1445 NEW YORK AVENUE NW

PROPOSED RENOVATIONS

COMMISSION OF FINE ARTS

CONCEPT REVIEW SUBMISSION

ARCADE INFILL + ENTRANCE CONFIGURATION

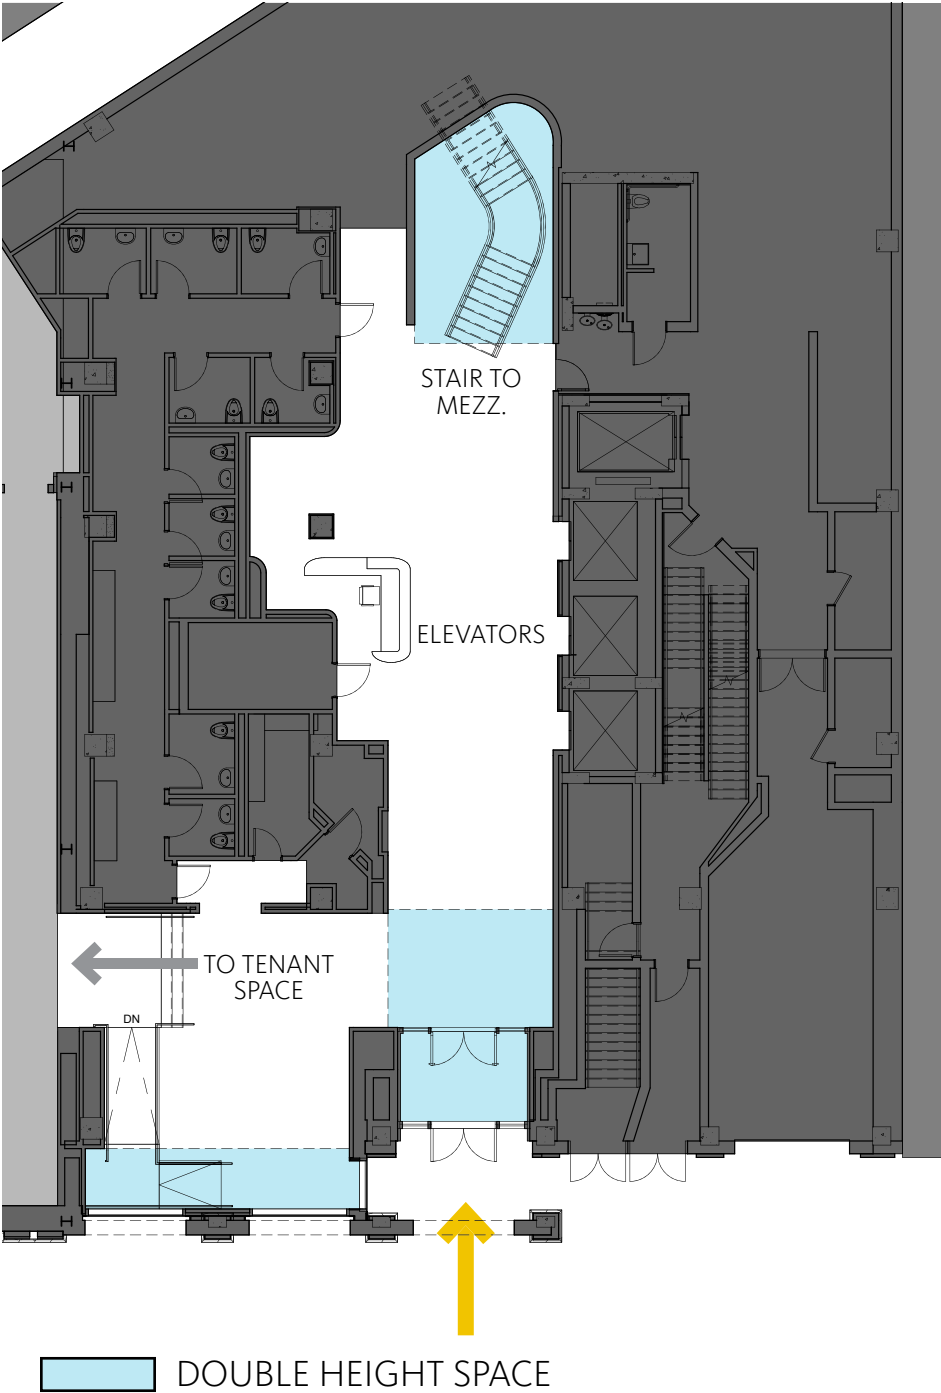
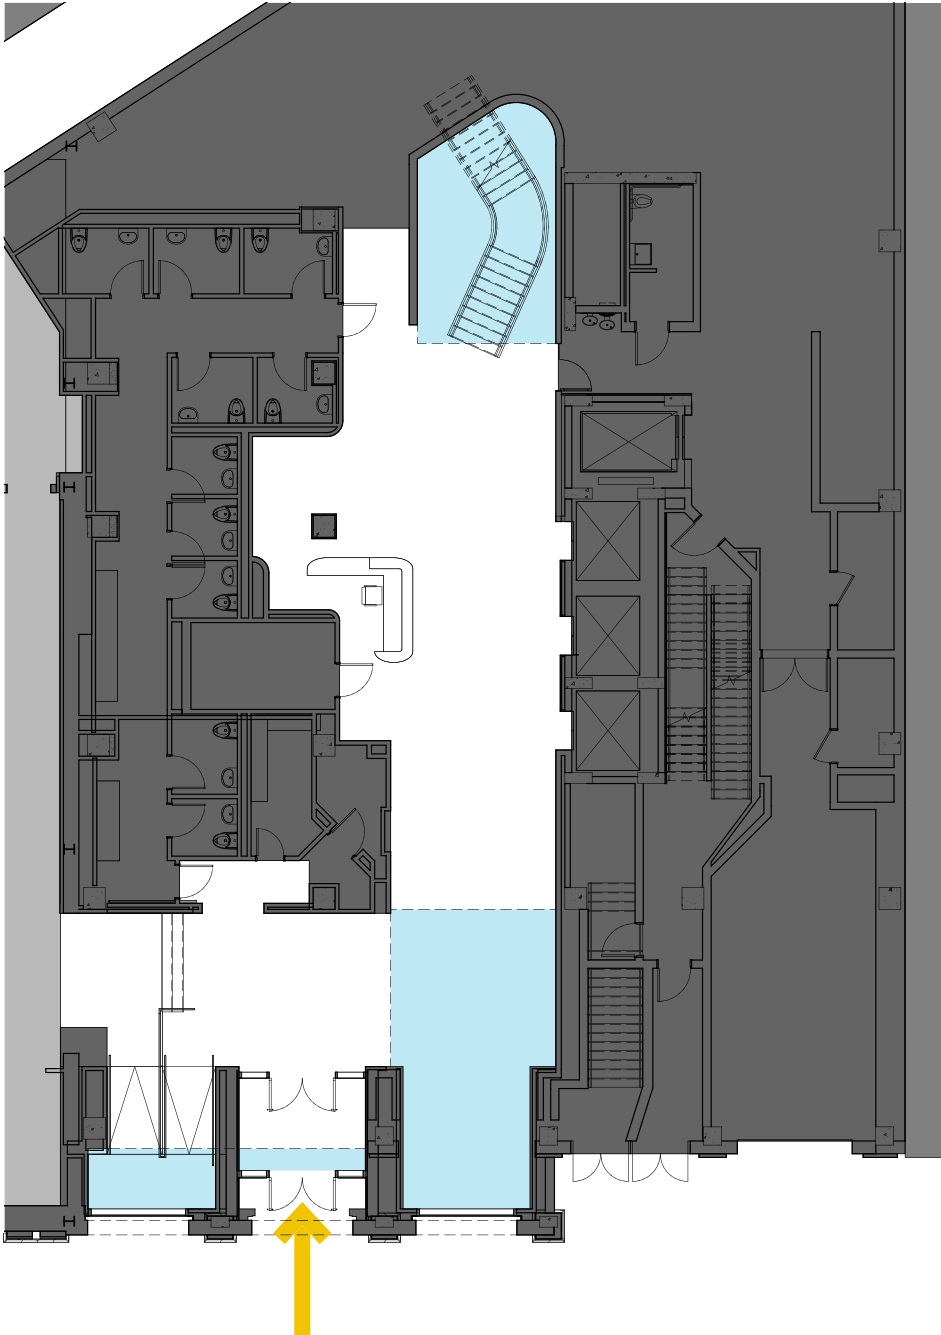
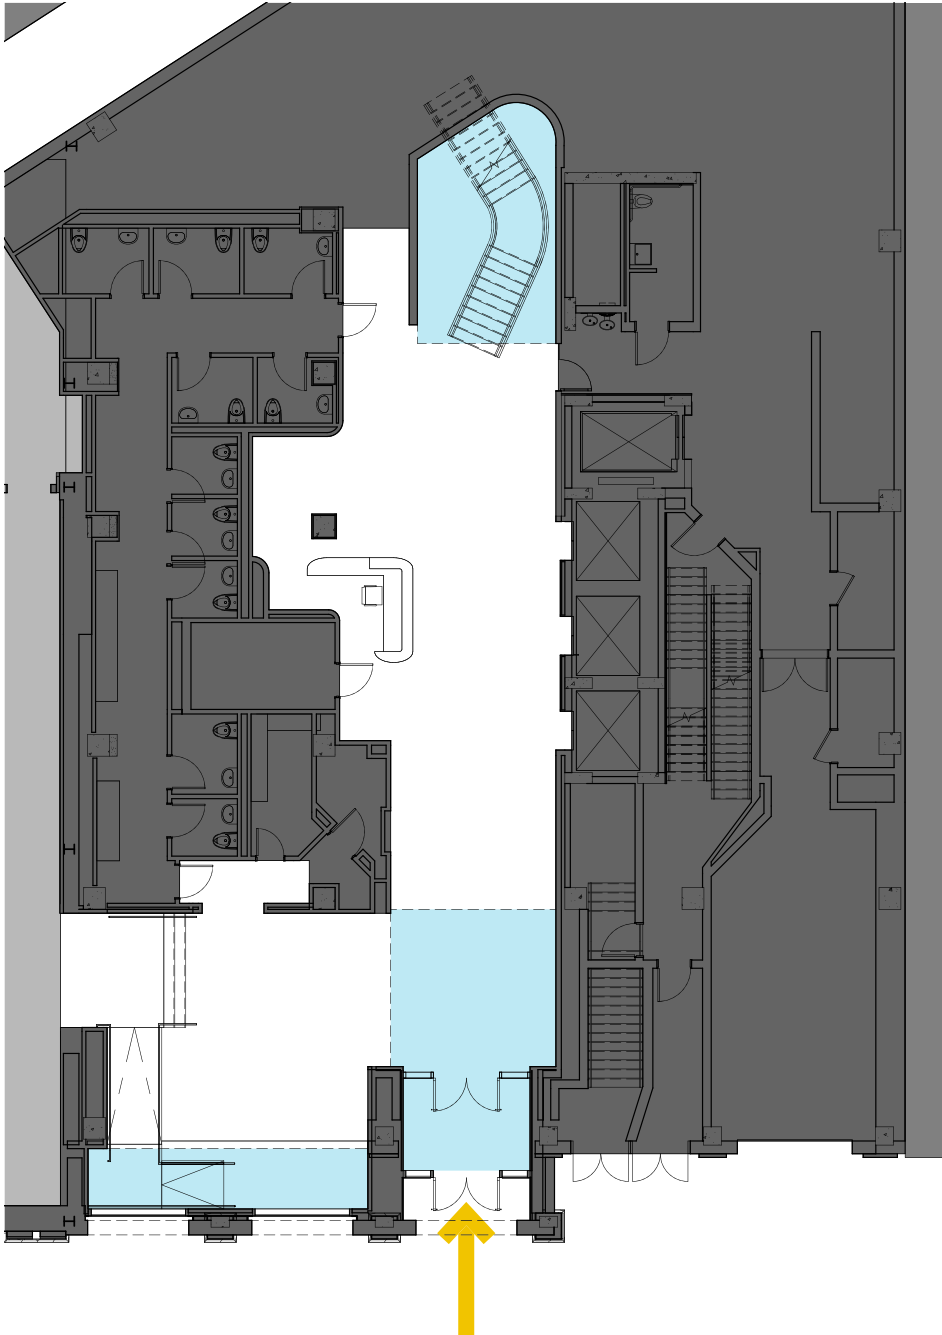
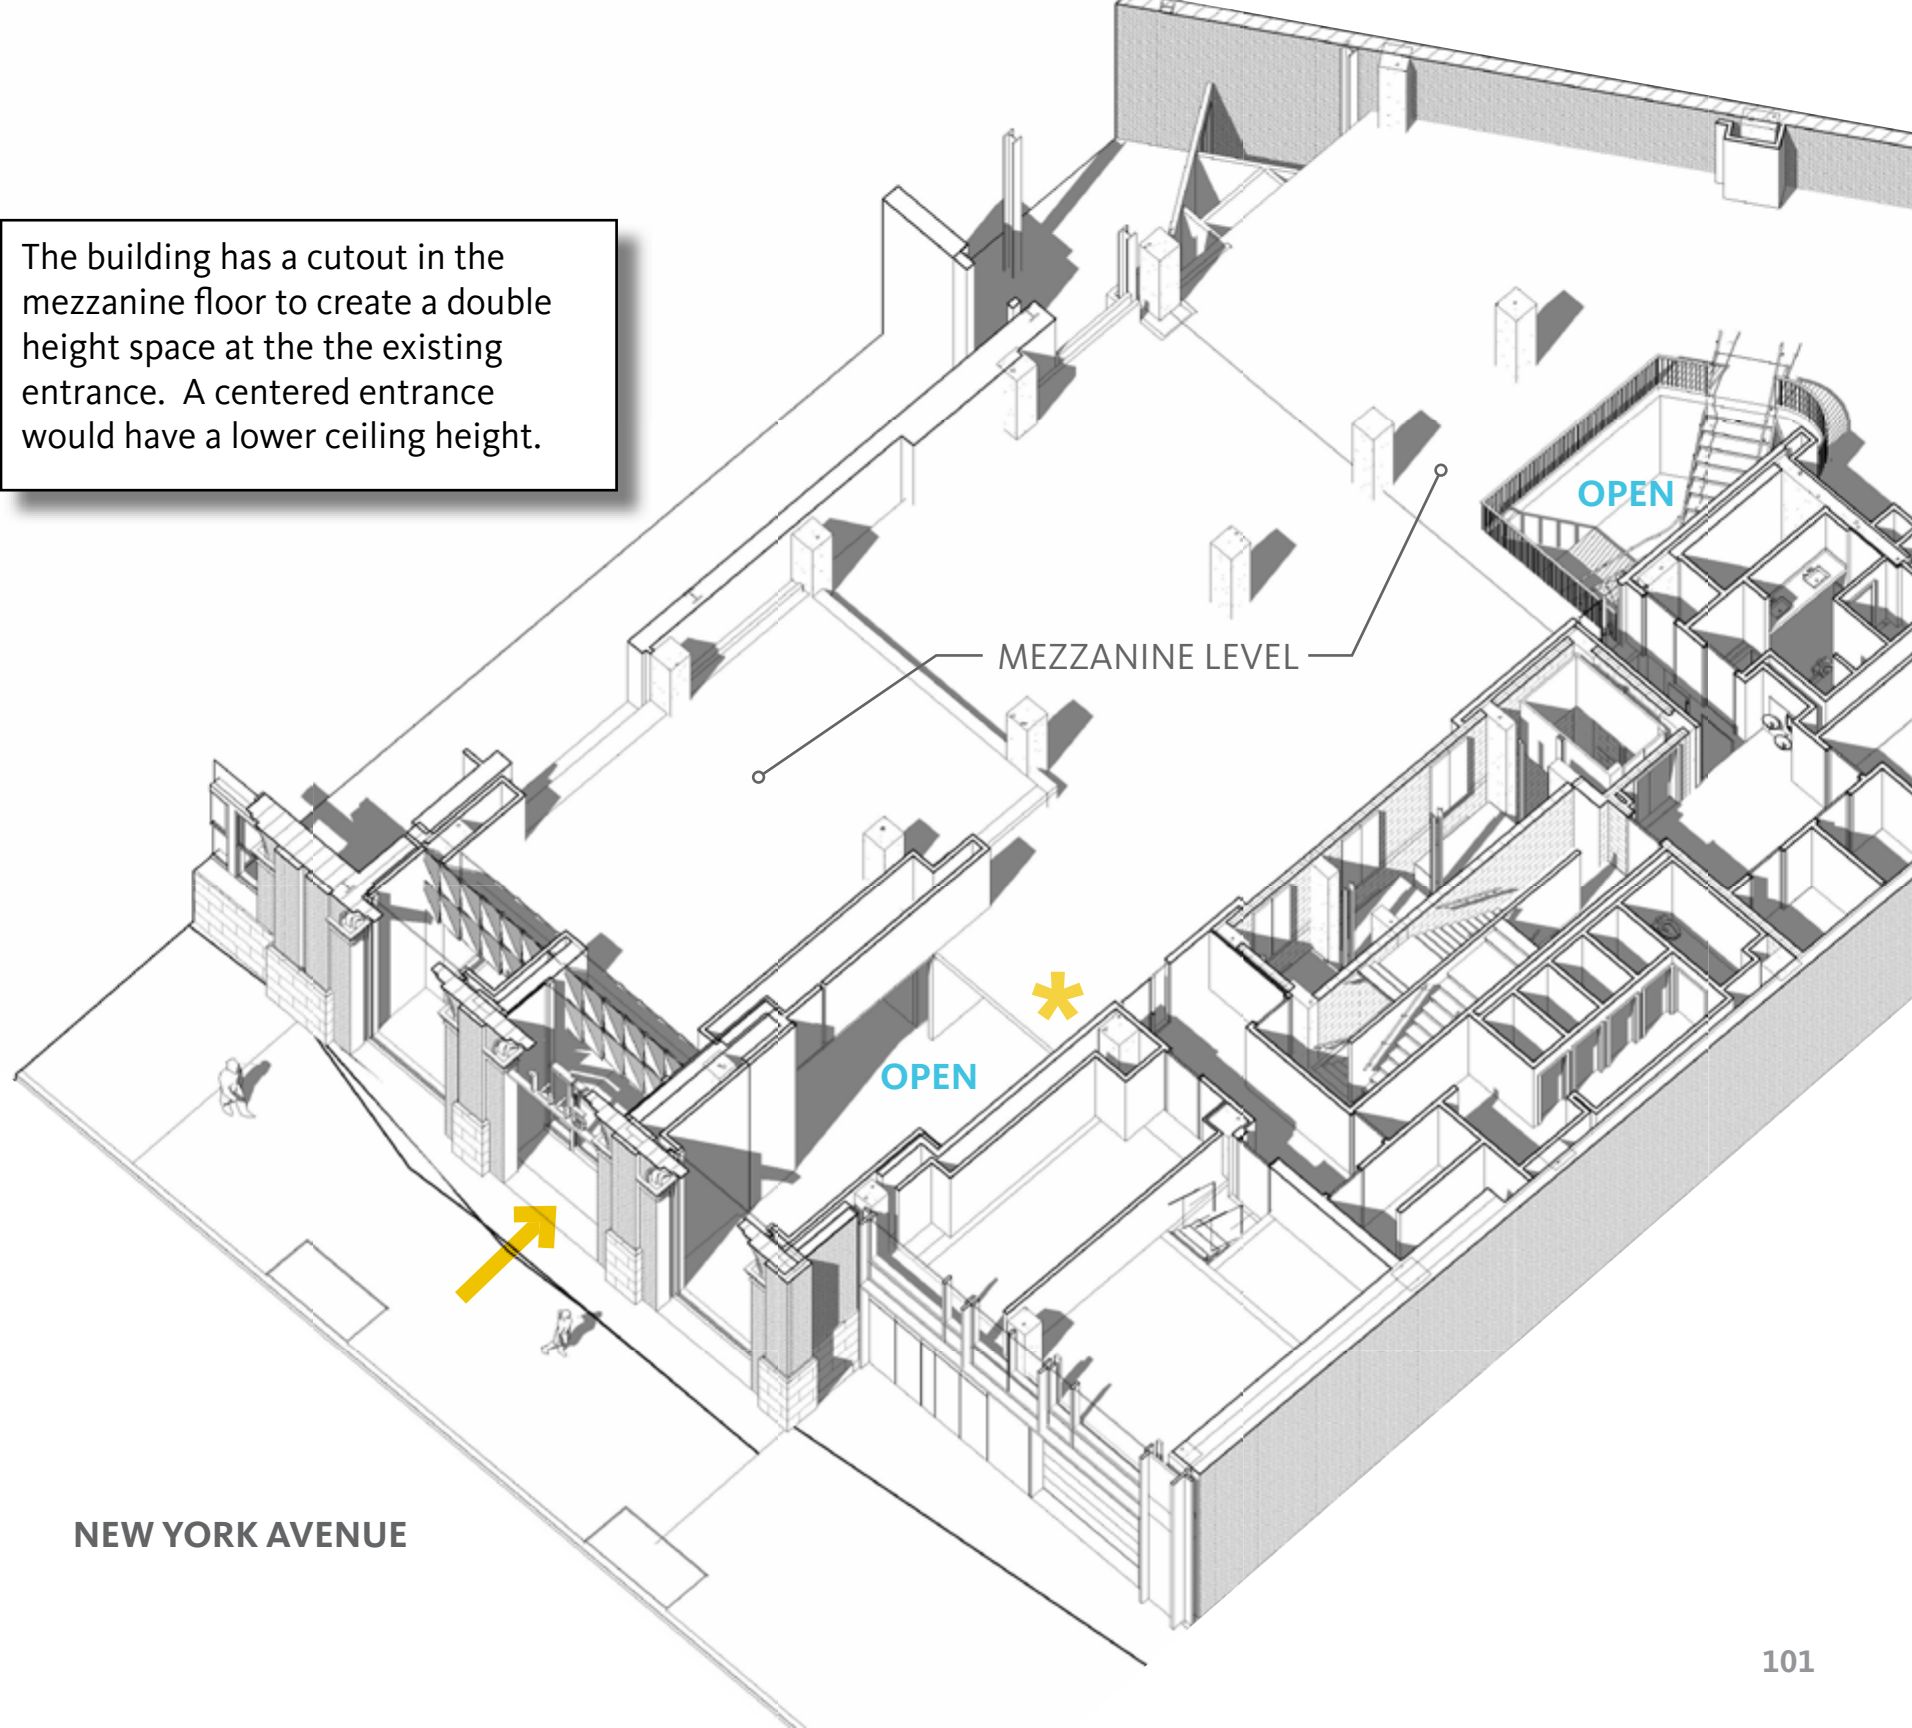
Study relocating building entrance to center bay of 1984 "transitional" façade

The building has a cutout in the mezzanine floor to create a double height space at the existing entrance. A centered entrance would have a lower ceiling height.
